**PLANNING AND ZONING COMMISSION MEETING
(SPECIAL & REGULAR MEETING)**

WEST BRANCH VILLAGE EXPANSION PLANS

From: Dave Schechinger <dschechinger@v-k.net> on behalf of Dave Schechinger
Sent: Tuesday, June 29, 2021 4:37 PM
To: 'leslie'
Subject: Fwd: West Branch Village Improvement Plans
Attachments: WEST BRANCH VILLAGE IMP PLANS.pdf

Attached are the revised plans for the West Branch Village expansion. Per your comments we have added the following changes:

SHEET NO.
L.01

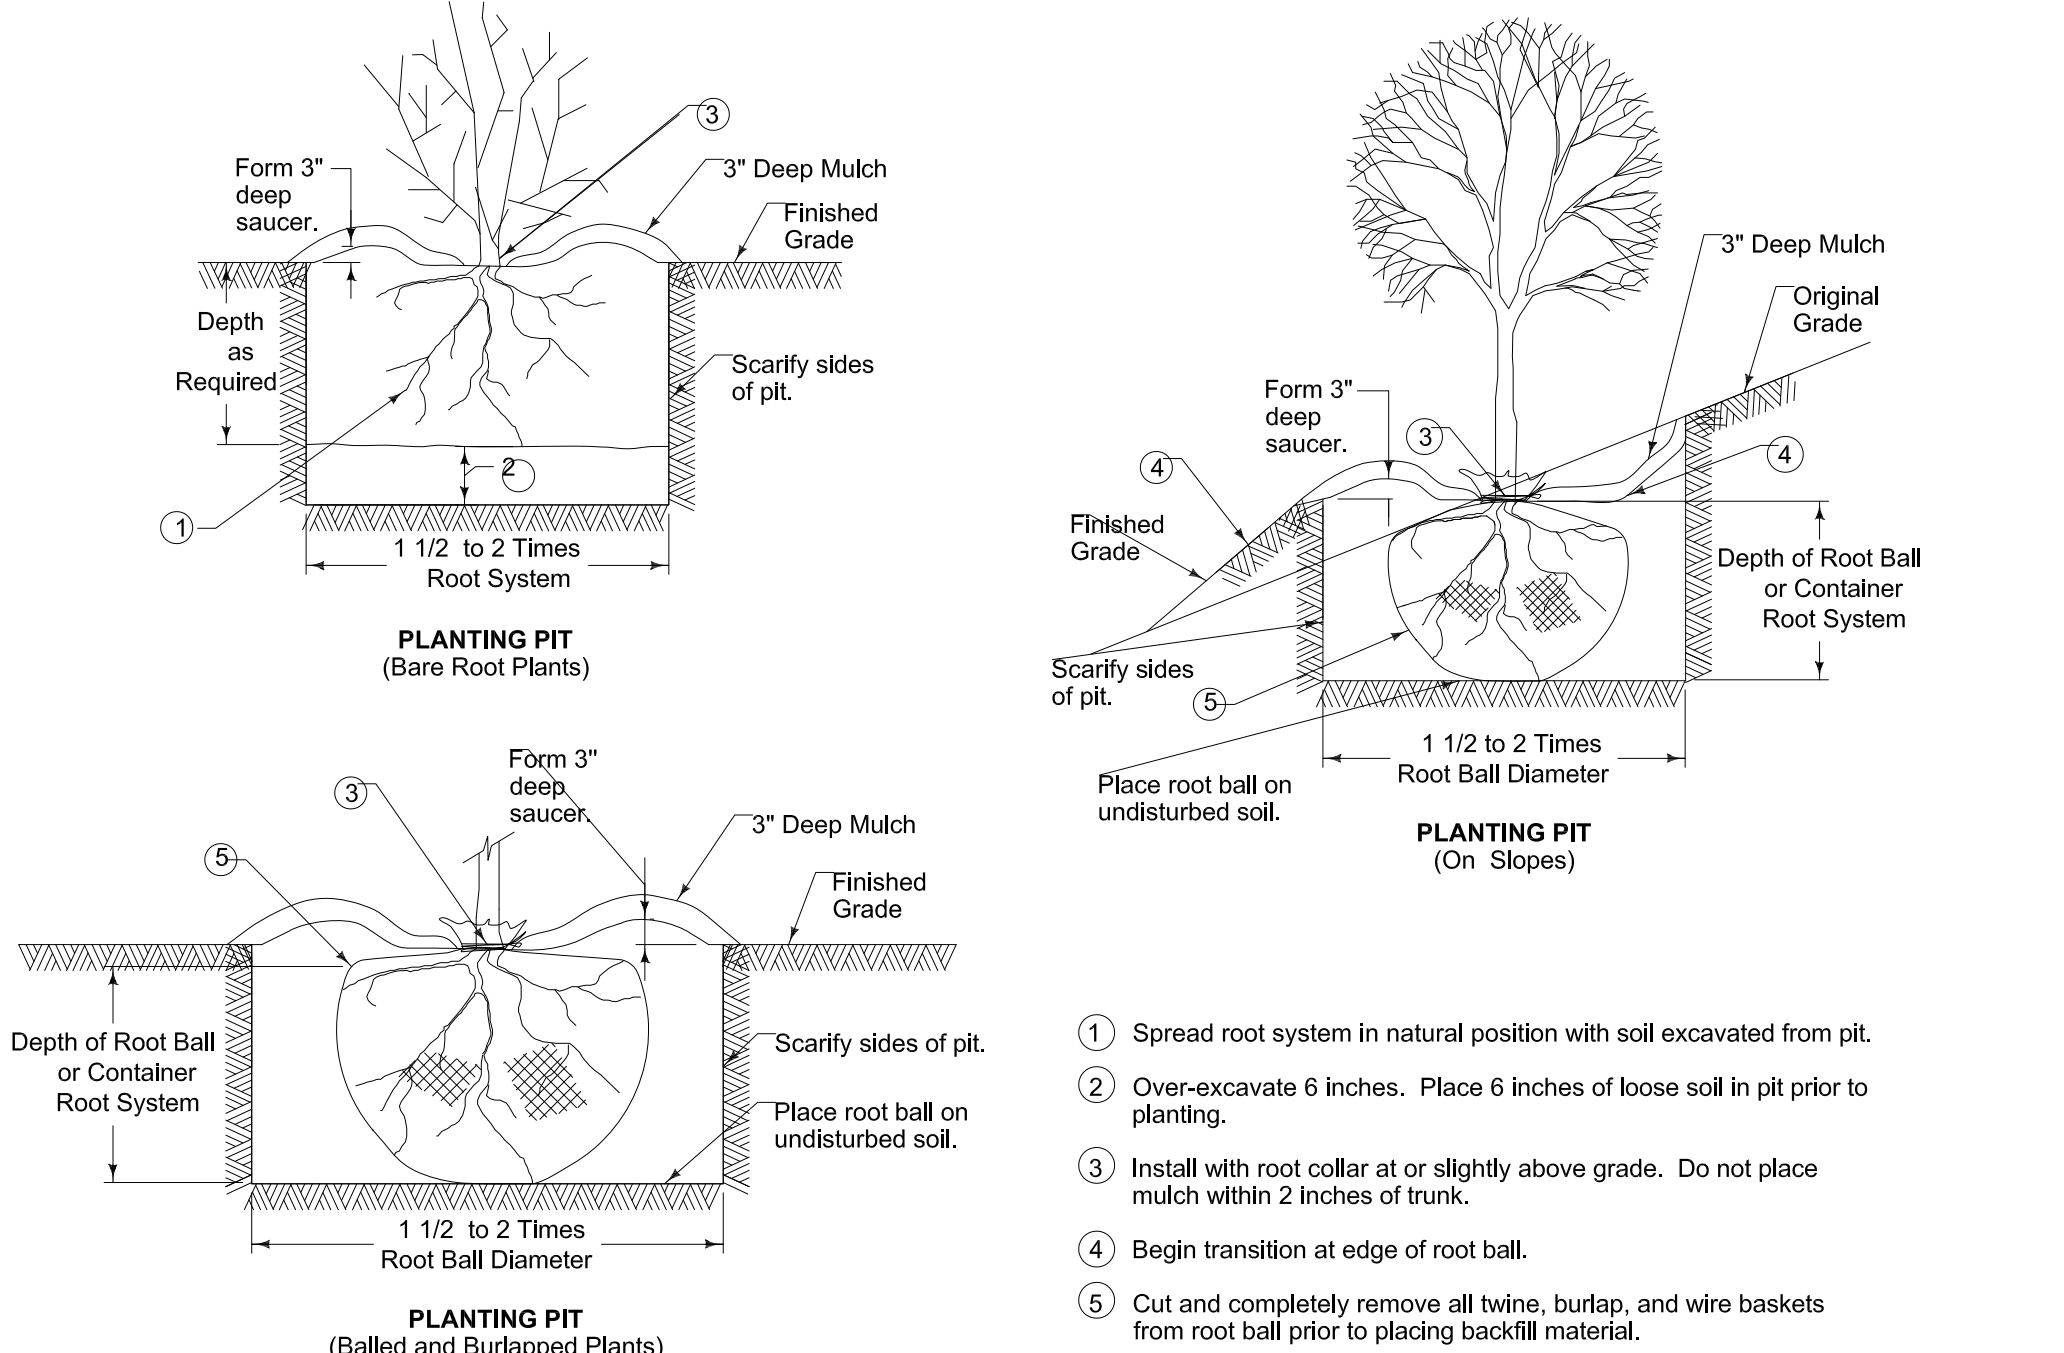
- Lighting will be installed through the expansion area in a similar fashion to the existing roads.
- A landscaping plan is shown on Sheet L.01 of the plans.
